Subject: Response to Third Submittal for Zoning Clearance #PP2023-6297

Thank you for submitting an amended Zoning Clearance application for the proposed 34-unit low-barrier navigation center located at 118 1st Street (APN: 017-172-32), 5 Cherry Court (APN: 017-172-31), and 120 1st Street (APN: 017-172-35). Based on the information provided, the application is complete and the Zoning Clearance has been approved.

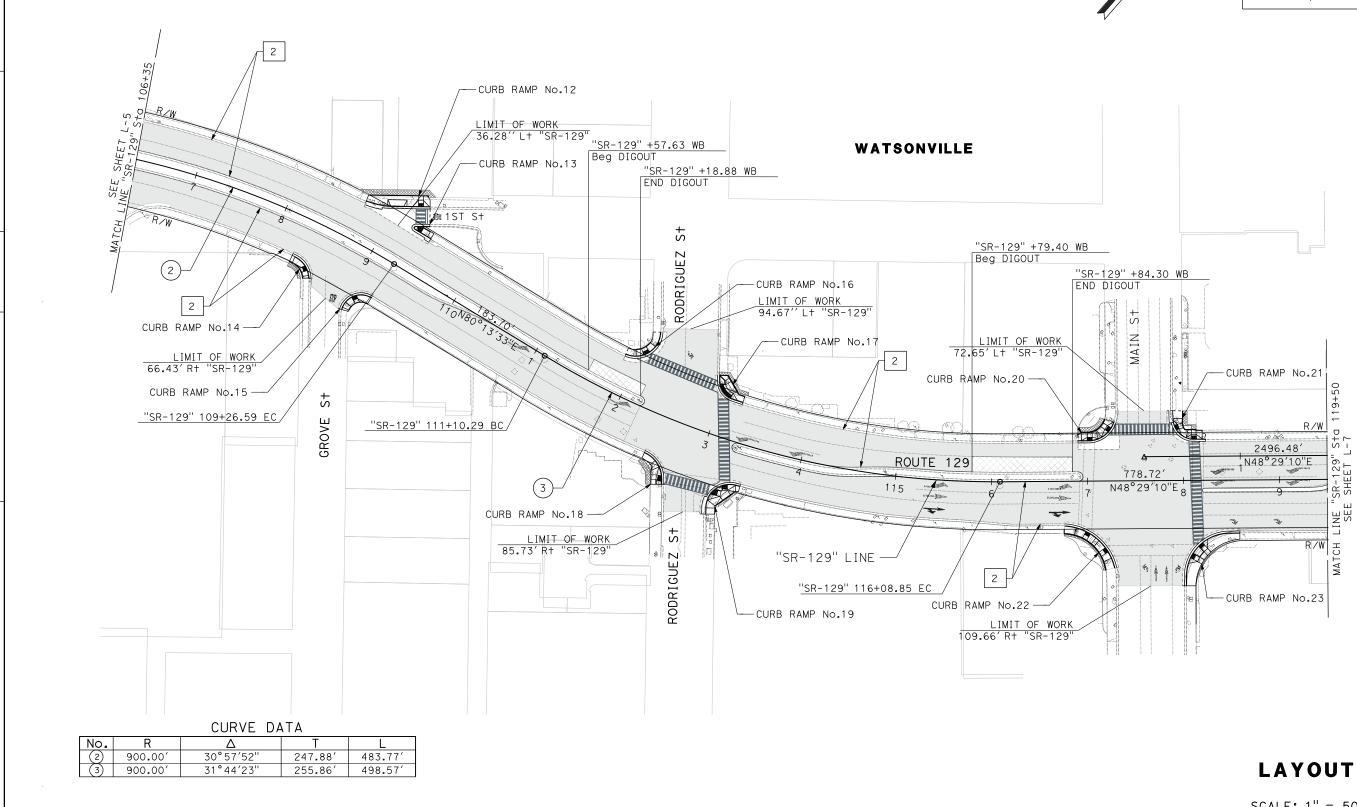
- 16. Sheet C2.1 Caltrans has a project that proposes improvements to the driveway and sidewalk in front of the project to be constructed in 2024. Revise plans to show proposed improvements and coordinate with Caltrans on these improvements. See attached plan.
